**NEW YORK STATE THRUWAY AUTHORITY  
DEPARTMENT OF ENGINEERING**

**AMENDMENT NO. 1  
TO**

**CONTRACT TAB 25-15**

**SAFETY IMPROVEMENTS AND MISCELLANEOUS WORK ON I-90  
FROM MP 467.00 TO MP 485.50 WB AND MP 467.00 TO MP 483.00 EB  
IN THE BUFFALO DIVISION  
OF THE NEW YORK STATE THRUWAY  
IN CHAUTAUQUA COUNTY**

DRAWING NUMBER:  
WZTC-05

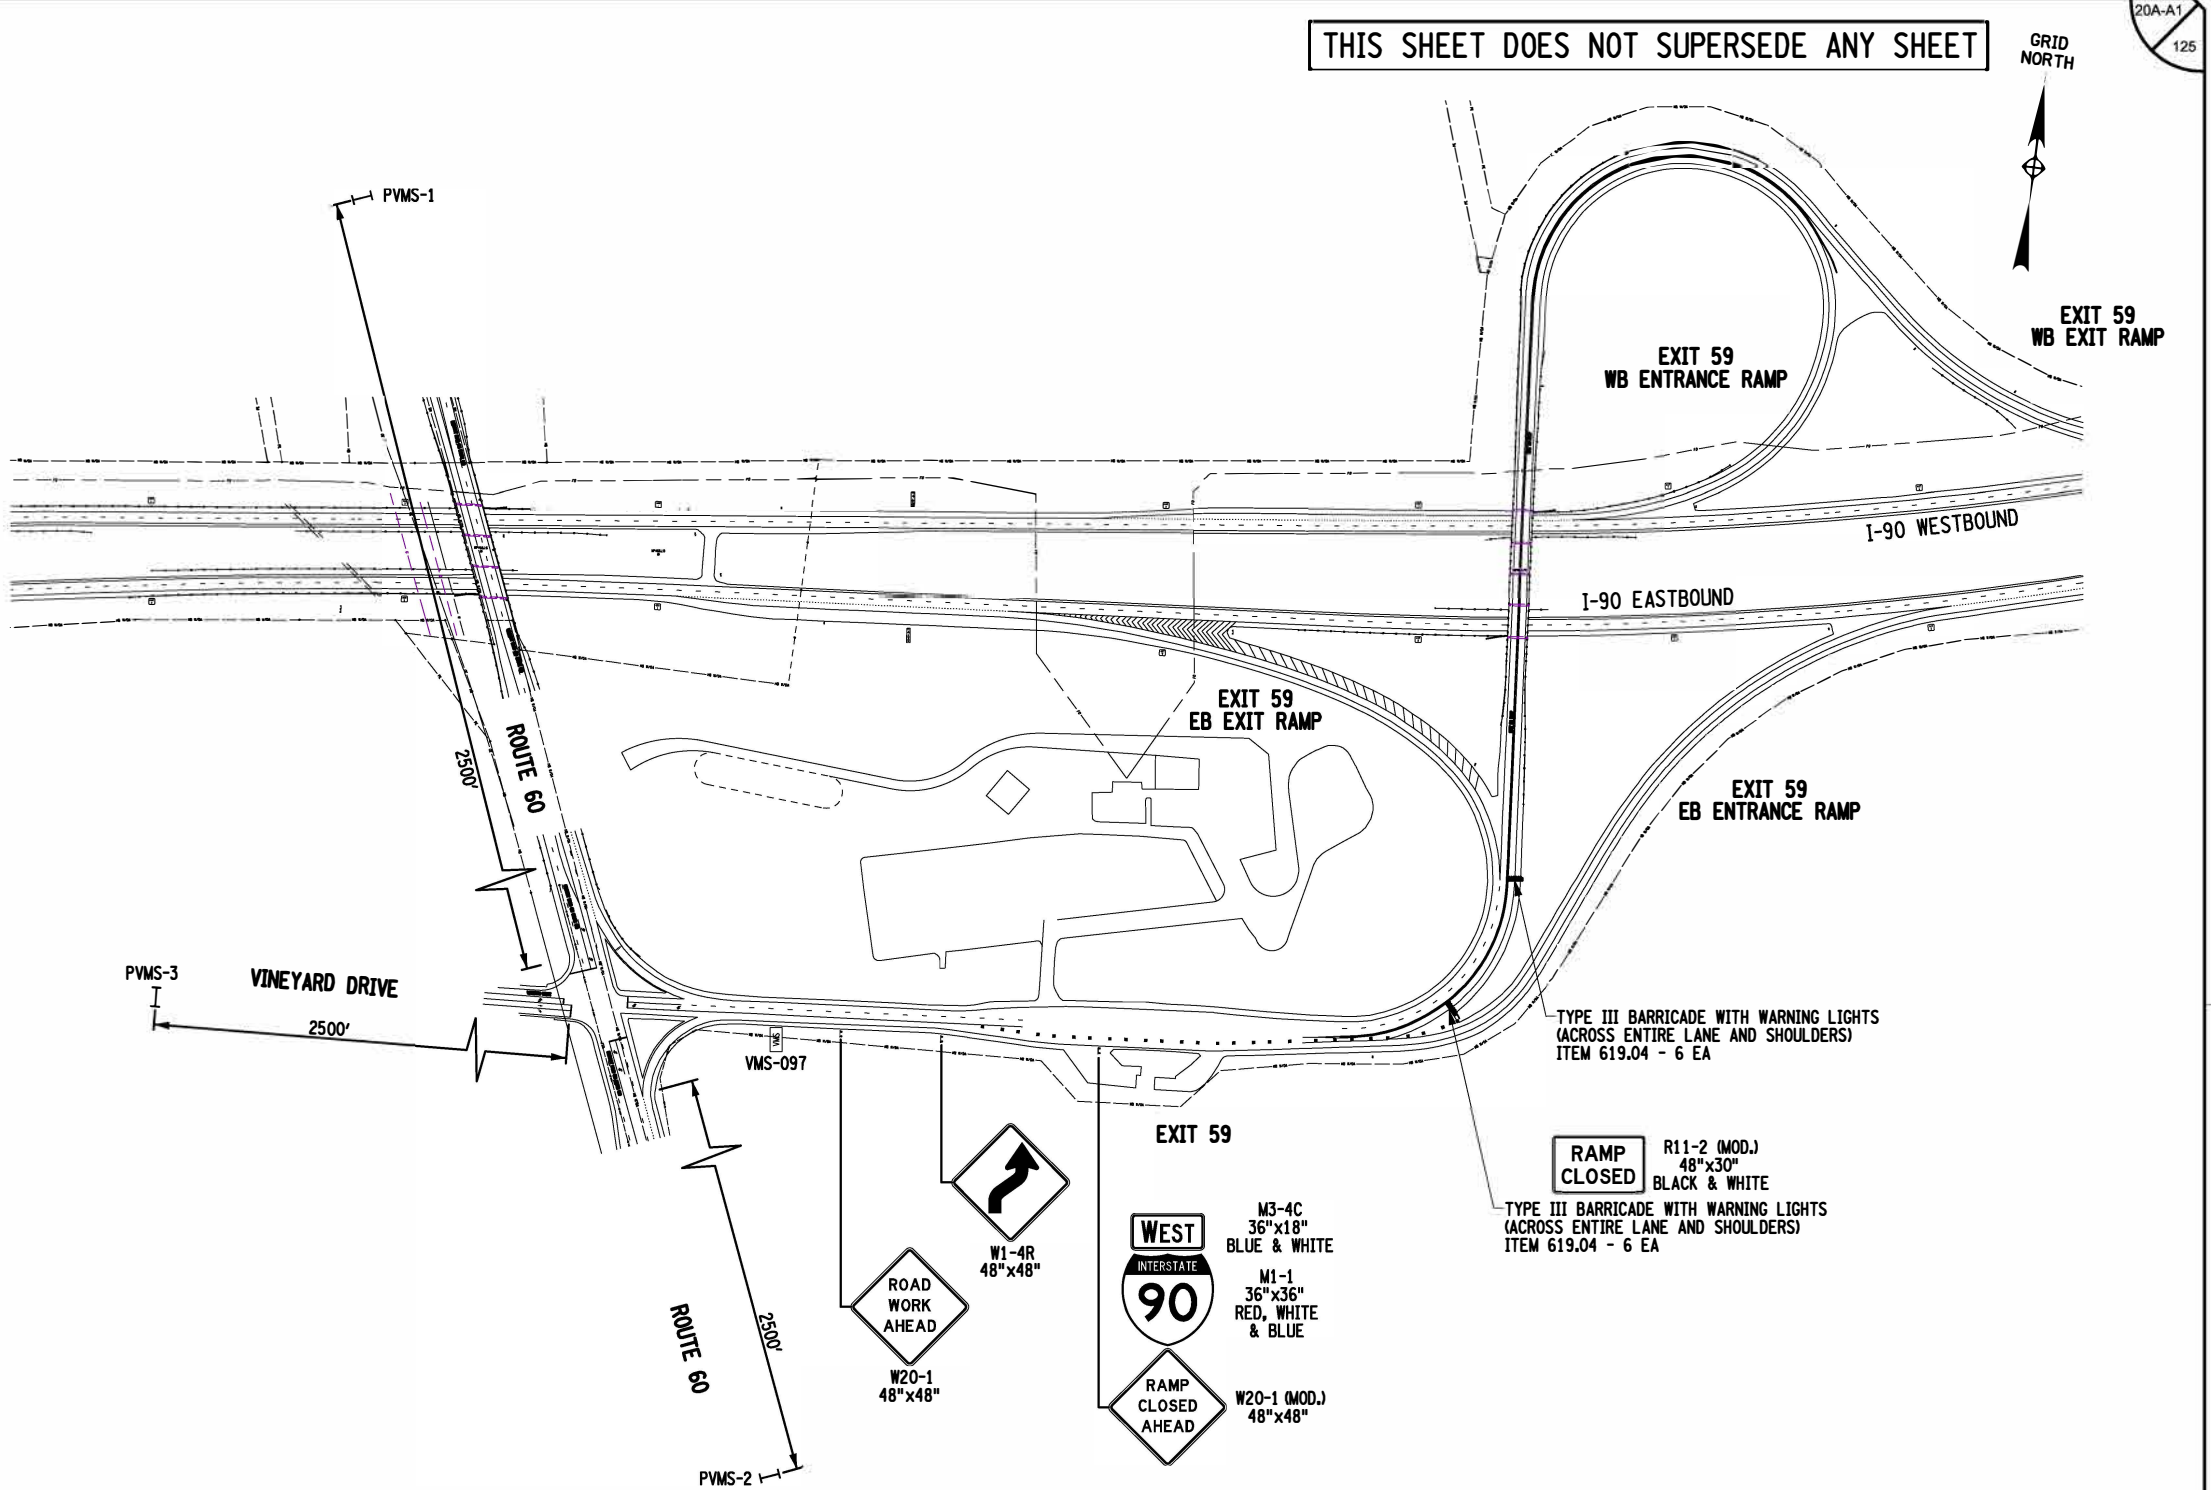
3. **ADD** Drawing Number WZTC-05, Sheet 20A-A1 of 125. The Work Zone Traffic Control for the Nighttime Westbound Entrance Ramp Closure at Exit 59 is now available.
4. **ADD** Drawing Number WZTC-06, Sheet 20B-A1 of 125. The Work Zone Traffic Control for the Nighttime Westbound Exit Ramp Closure at Exit 59 is now available.
5. **ADD** Drawing Number MSD-1, Sheet 125A-A1 of 125. Miscellaneous details regarding the installation of the single slope concrete barrier is now available.
